**CAPSTONE HOUSE
ELEVATOR CONTROLS UPGRADE
UNIVERSITY OF SOUTH CAROLINA
STATE PROJECT NO: H27-Z396/50003361-2**

**Addendum Three
March 23, 2021**

**CAPSTONE HOUSE ELEVATOR CONTROLS UPGRADES
UNIVERSITY OF SOUTH CAROLINA
COLUMBIA, SC
ELECTRICAL ITEMS - ADDENDUM NO. 3
March 23, 2021**

2 PARTIAL POWER RISER DIAGRAM

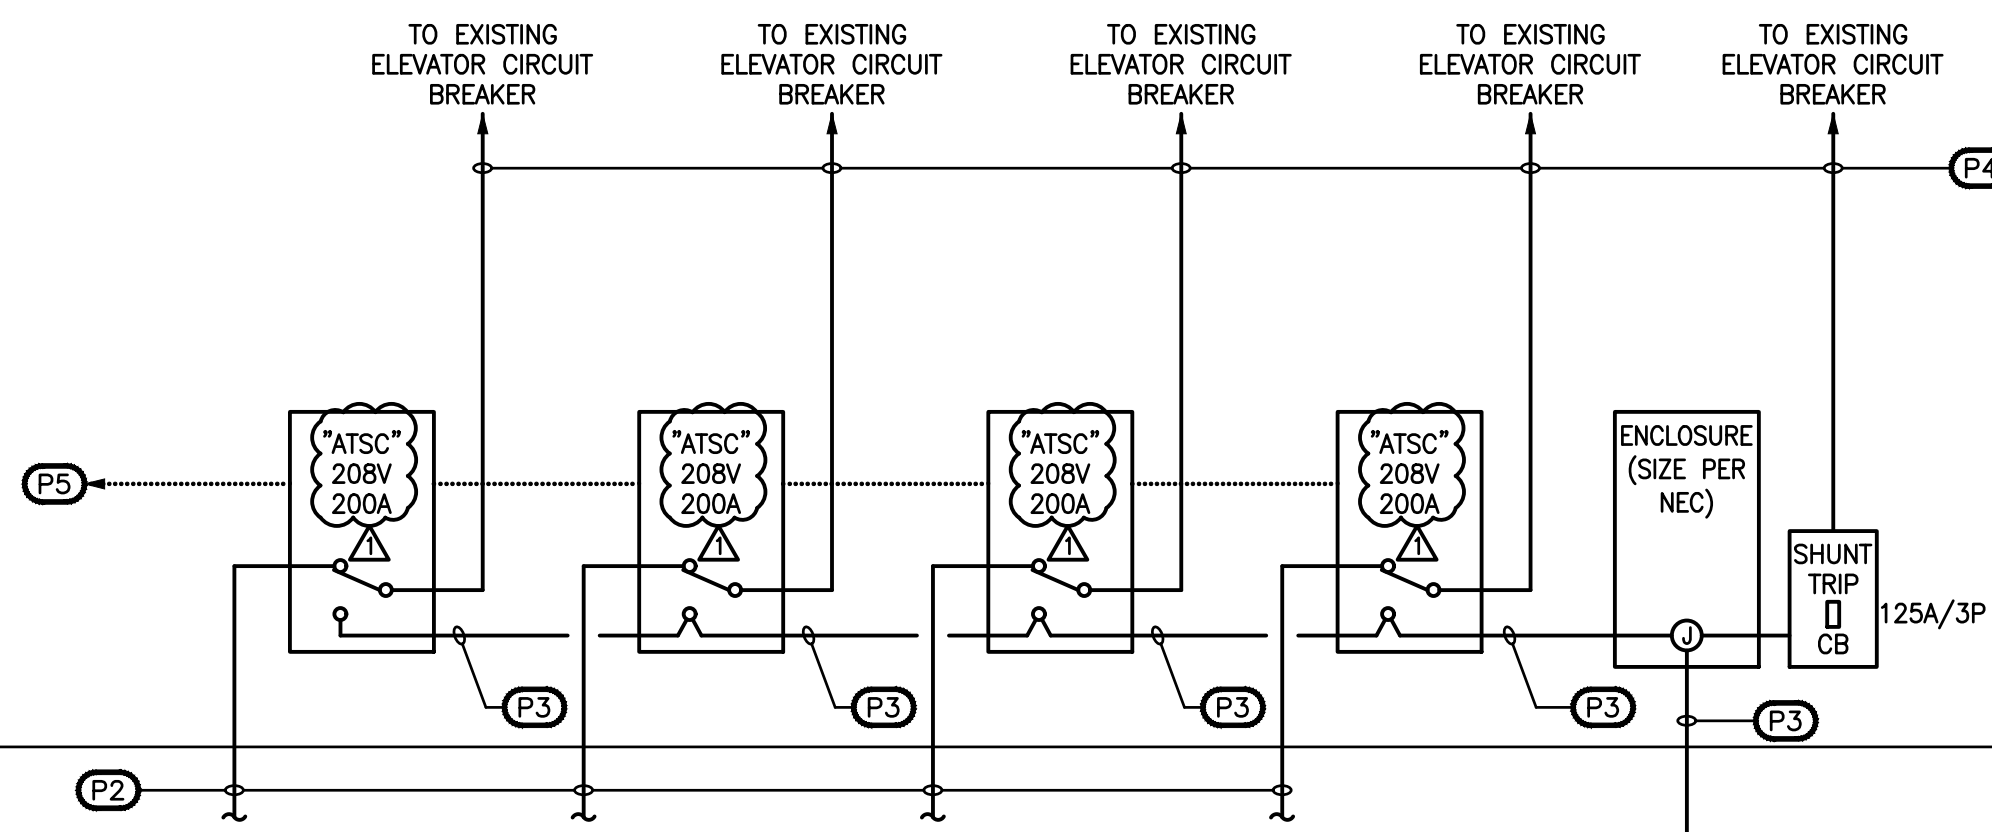
1. **SHEET E601 ELECTRICAL DETAILS:**

- Delete E601 and replace it with the attached E601 (added ATS sizes & ATS feeder size).

- (P1) NOT USED.
- (P2) EXISTING ELEVATOR DISCONNECT FEEDERS: RECONNECT TO NEW TRANSFER SWITCHES.
- (P3) EXISTING EMERGENCY STANDBY ELEVATOR FEEDER: 1#6G, 3#1/0, 2#GRC. SPLICE/EXTEND/REROUTE TO TRANSFER SWITCHES AS NOTED.
- (P4) EXISTING ELEVATOR CIRCUIT BREAKER FEEDERS: RECONNECT TO NEW TRANSFER SWITCHES.
- (P5) CONTROL CIRCUIT TO ELEVATOR SELECTOR PANEL LOCATED ON FIRST FLOOR, 3/4\"/>
